RIVER DISTRICT DESIGN COMMISSION REGULAR MEETING AGENDA

April 11, 2024

DATE: April 11, 2024
TO: River District Design Commission
FROM: Renee Burton, Division Director of Planning
RE: Certificate of Appropriateness application PZ24-00120 filed by Rivermont Danville, LLC to construct a parking garage at 403 Spring Street.

Danville Parking Deck
403 Spring Street, Danville, VA 24541

NORTHWEST CORNER LOOKING FROM SPRING ST. AND N. UNION ST.
SCALE: NTS

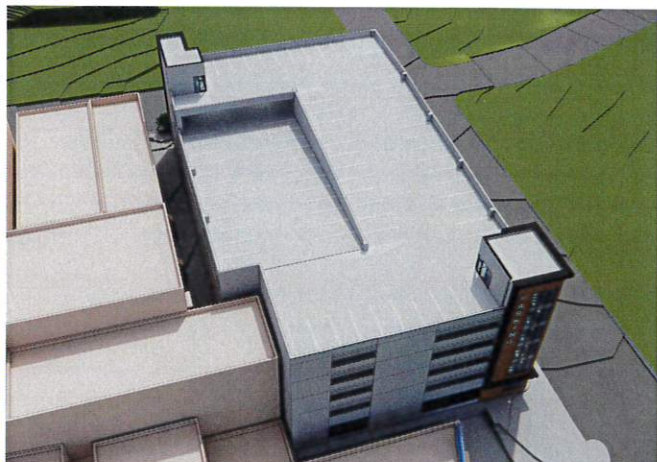
On March 14, 2024, the River District Design Commission postponed this request. The Commission requested that the applicant adjust the presented design(s) to increase the vertical appearance and add more brick detail to the facade. The applicant has submitted two (2) additional design options for review and an attached design narrative.

Option 1 – After some initial feedback on the Original Scheme we decided to add more vertical elements and further integrate the design into Union Street with all its historic buildings. We started by proposing a brick that is similar to the buildings on Craghead Street which added to the variety of brick colors on Union Street. We also clad all the exterior columns in brick so that they are wider and project beyond the spandrels of the garage. These masonry columns now go all the way to the ground to help further accentuate the verticality of the building. We also added brick to all three of the exposed elevations making it the predominant material. We believe all these changes contribute to a design that will better integrate into the overall River District and Union Street in particular.

Option 2 – Similar to Option 1, but with added vertical accents on the East and West shear walls.

The Planning Staff recommends that the River District Design Commission approve PZ24-00120, Option 2. The applicant has adjusted the proposal based on the feedback received

from the Commission during its March 14, 2024, meeting. Option 2 presents vertical proportions, interrupted expansion of wall area in a logical rhythm and a brick facade in compliance with the River District Design Guidelines.
